Errata for the Compute Express Link™ (CXL™) Specification Revision 1.1

February 2020

E8 CXLCM Slot Format Diagram Updates

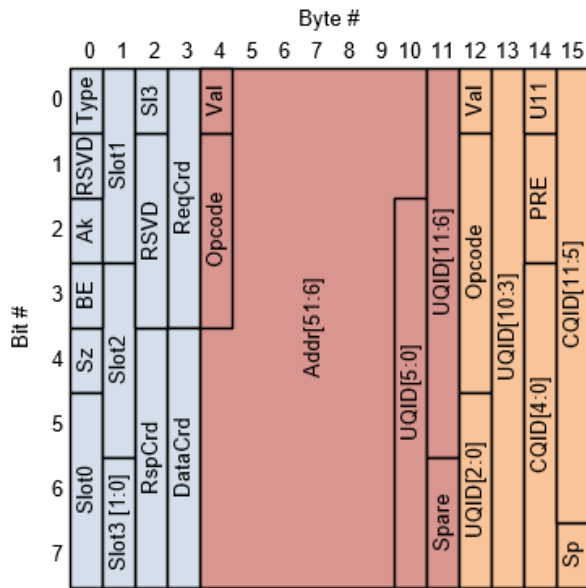
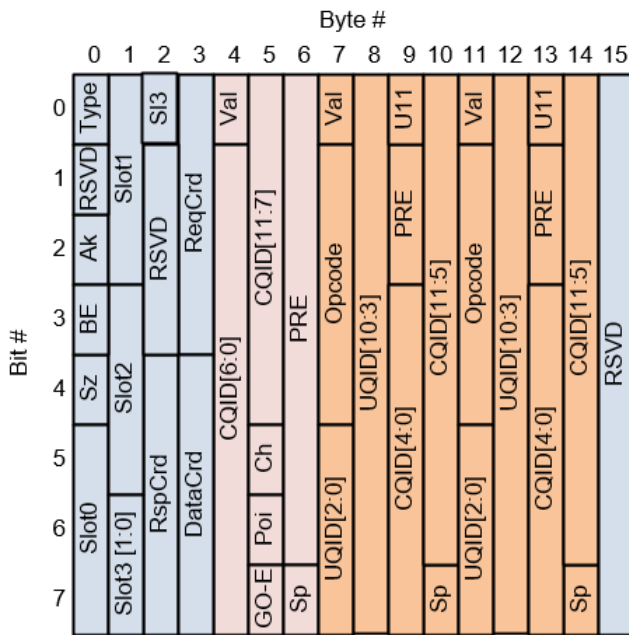
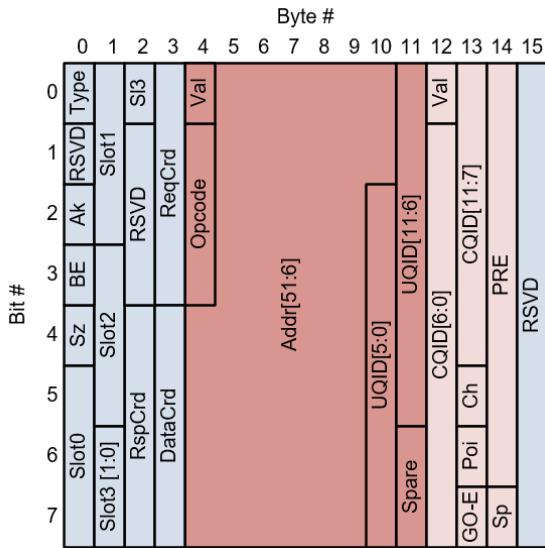
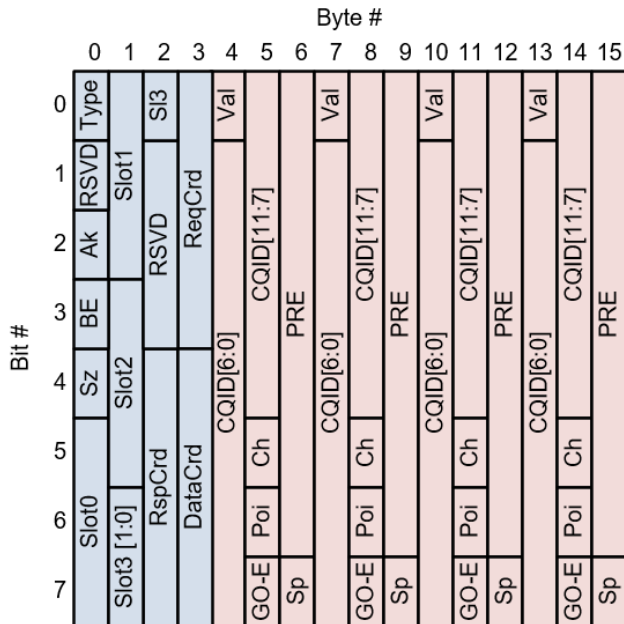
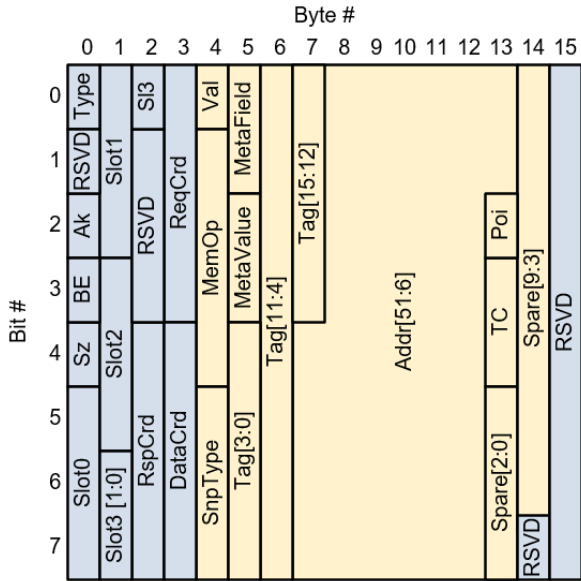
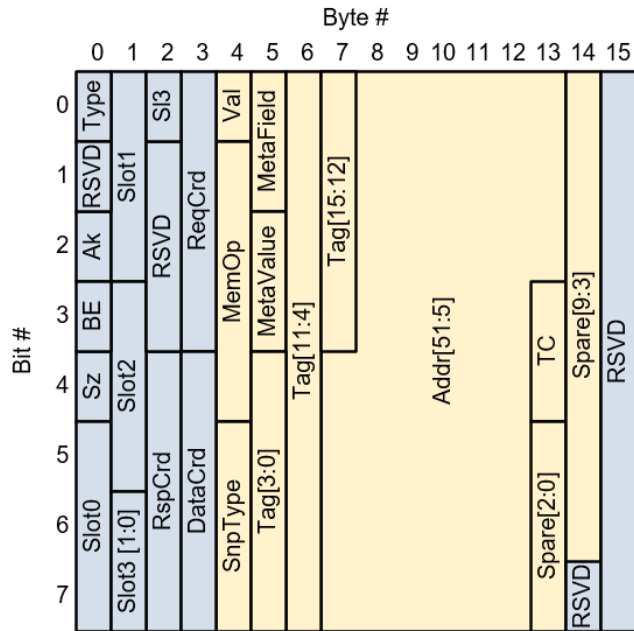
In Section 4.2.3, following diagrams for Header Slot Formats need to be updated to show Slot 3 bit encodings in correct bit positions. Also fixed Figure 50, which showed Addr[51:6] in CXL1.1, but should have show Addr[51:5] to match address bits required for M2S Req.

Figure 39. Write from Host

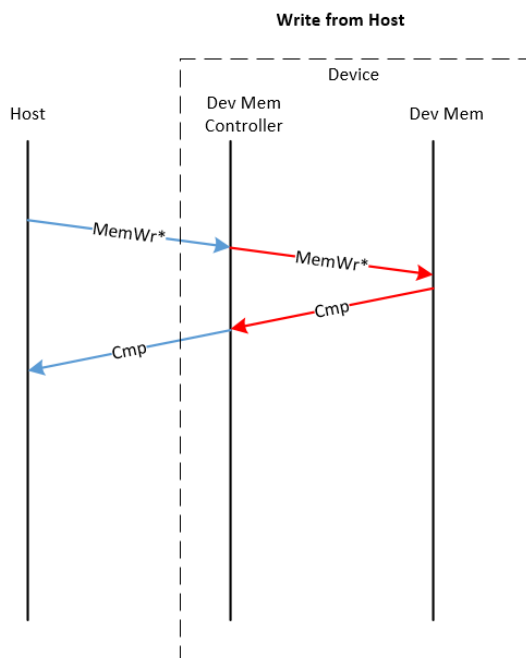
Update Figure 39, Red arrows from Device Memory Controller to Device Memory should be MemWr* and Cmp

Figure 70. G5 - ~~3~~₂ S2M NDR

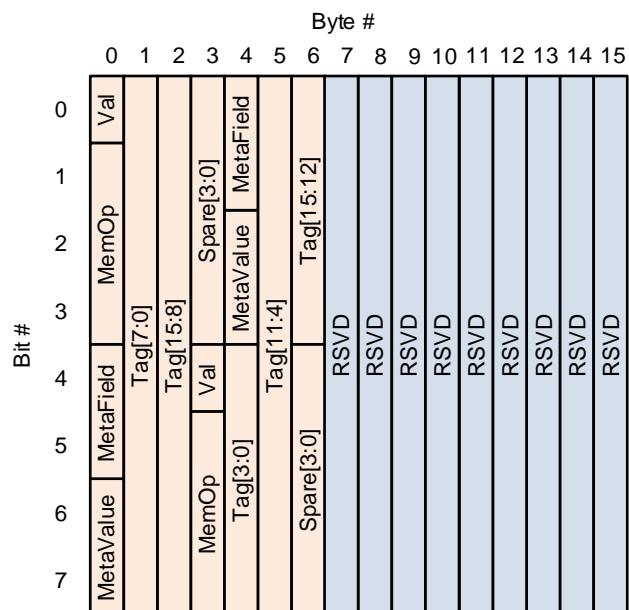
Updates to S2M/D2H G5 format from 3 NDR to 2 NDR messages. The global flit rules in section 4.2.5 restrict total S2M NDR to 2 total per flit which take precedence, so it is impossible to make use of 3rd NDR message in the S2M/D2H G5 format. Changing the G5 format to only include 2 NDR is done to ensure consistency and avoid confusion.

First change is to Table 40. Second change is to change G5 format in Figure 70 to include only the first 2 NDR messages converting the 3rd to RSVD bits.

Figure 94a. NULL Flit w/EDS and Sync Hdr Bypass Optimization

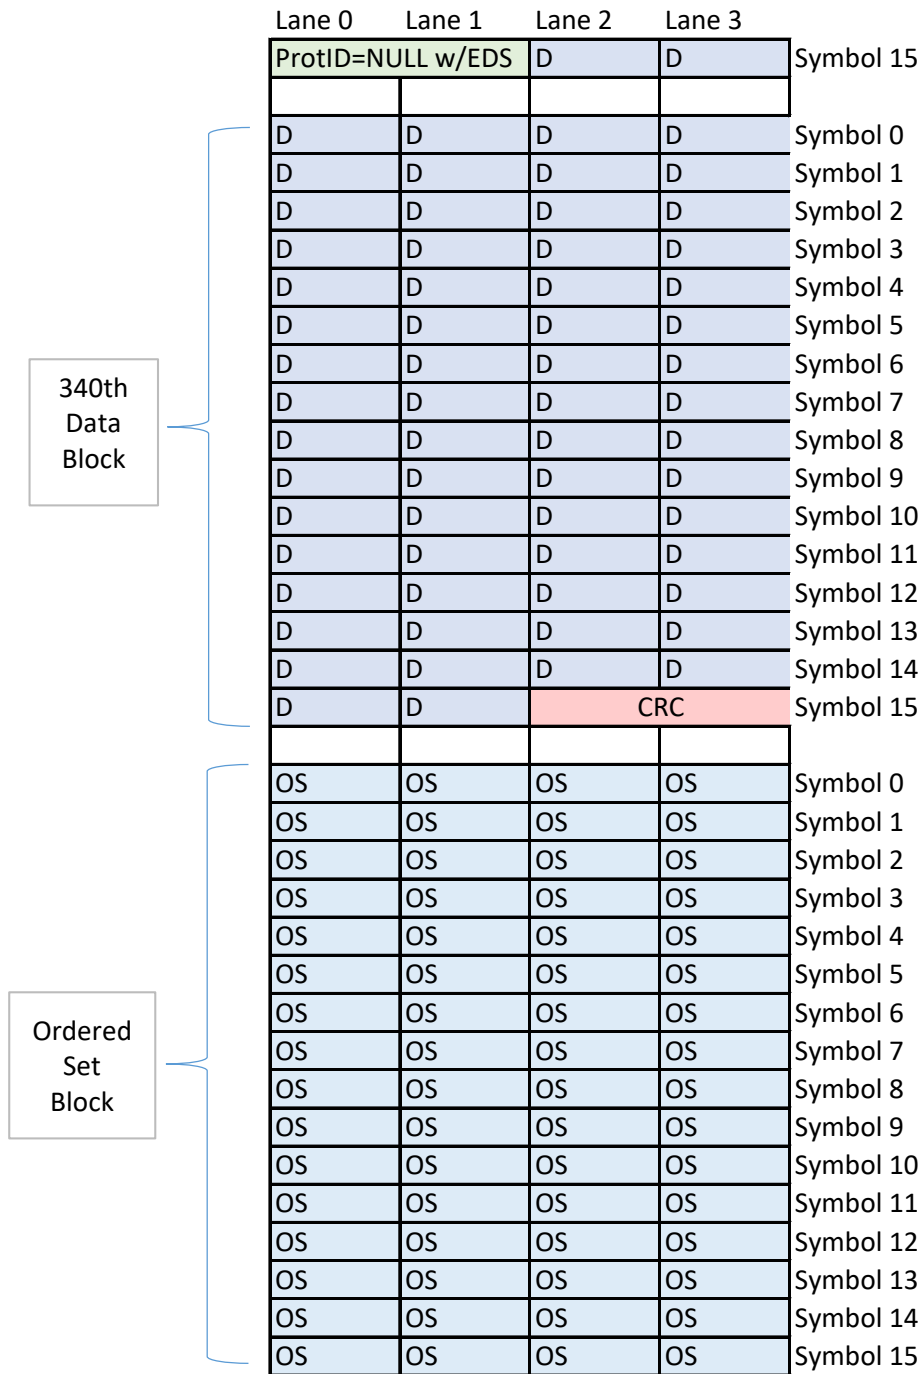
In section 6.2.2, make the below changes. Additionally, at the end of section 6.7.1, add text and Figures 94a and 94b that show examples of NULL with EDS usage. Note, the figure numbering will be updated when this errata is integrated into the specification.

[Figure 94a illustrates a scenario where a NULL flit with implied EDS token is sent as the last flit before exiting the data stream in the case where sync hdr bypass is enabled. In this example, near the end of the 339th block, the link layer has no flits to send, so the physical layer inserts a NULL flit. Since there is exactly one flit's worth of time before the next Ordered Set must be sent, a NULL flit with implied EDS token is used. In this case, the variable length NULL flit with EDS token crosses a block boundary and contains a 528 bit payload of zeros.](#)

Figure 94b. NULL Flit w/EDS with 128/130b Encoding

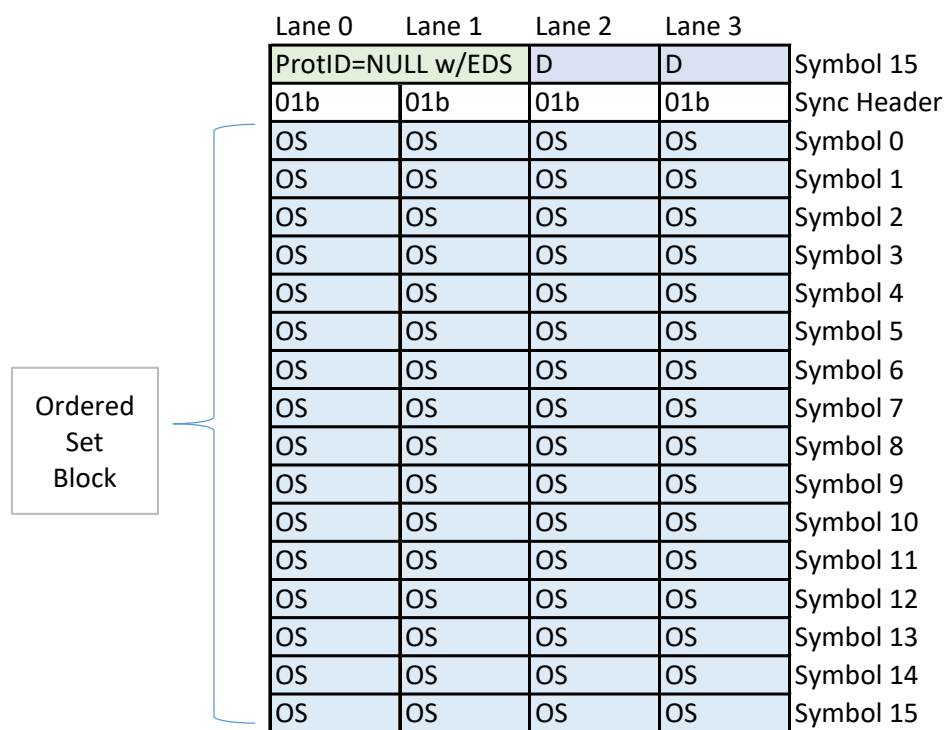
[Figure 94b illustrates a scenario where a NULL flit with implied EDS token is sent as the last flit before exiting the data stream in the case where 128/130b encoding is used. In this example, the NULL flit contains only a 16 bit payload of zeros.](#)
